WILLIAM E. EICK

February 4, 2005

Re: *Proper Calculation of Slope Density Ordinance*
Case No CPC 2004-4344
CPC 2004-4345
Vesting Tentative Tract No 61672
7000-8000 La Tuna Canyon Road
California Whitebird Inc (O)(A)

Exhibit 5

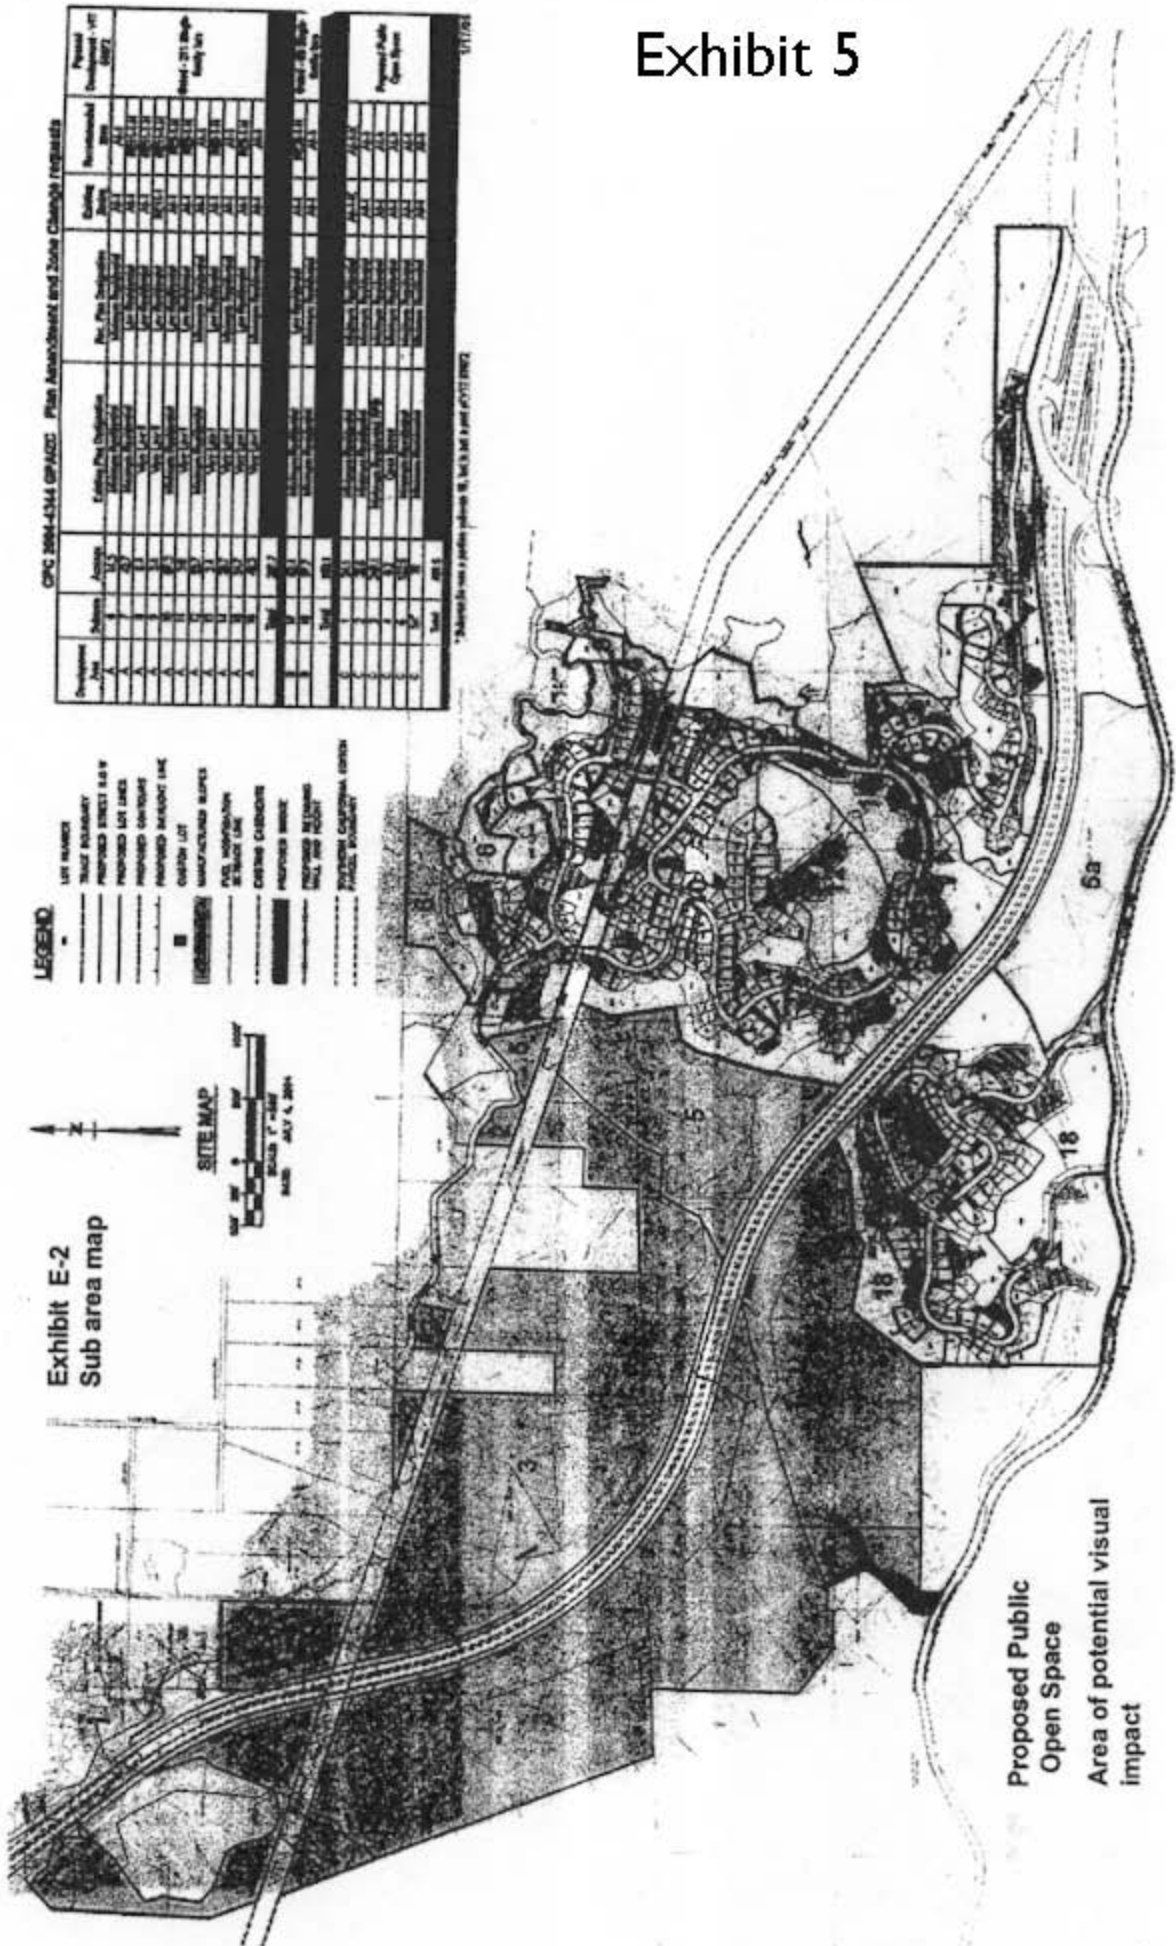
- 3.5. The developer's slope density map includes grids 209 and 210 which are not part of the project area. Compare the developer's Slope Density Map with Exhibit E-2 of the Mr. Dueñas report (See Exhibit 5). These additional grids inappropriately add 5.9 dwelling units regardless of the method of calculation.

- 3.6. The developer's slope density map calculates that there are 903.3 acres in the project. However every description of the project lists the acreage at 887 acres. Grids 209 and 210 are not part of the project as described in the EIR and account for a total of 9.9 acres. This still leaves 6 unaccounted acres. For purposes of this letter the 903.3 acres refers to the calculations on the developers slope density map even though that number does not correspond to the project description in the EIR. The 903.3 acres shall hereafter be referred to in quotes to note the inconsistency ("903.3").
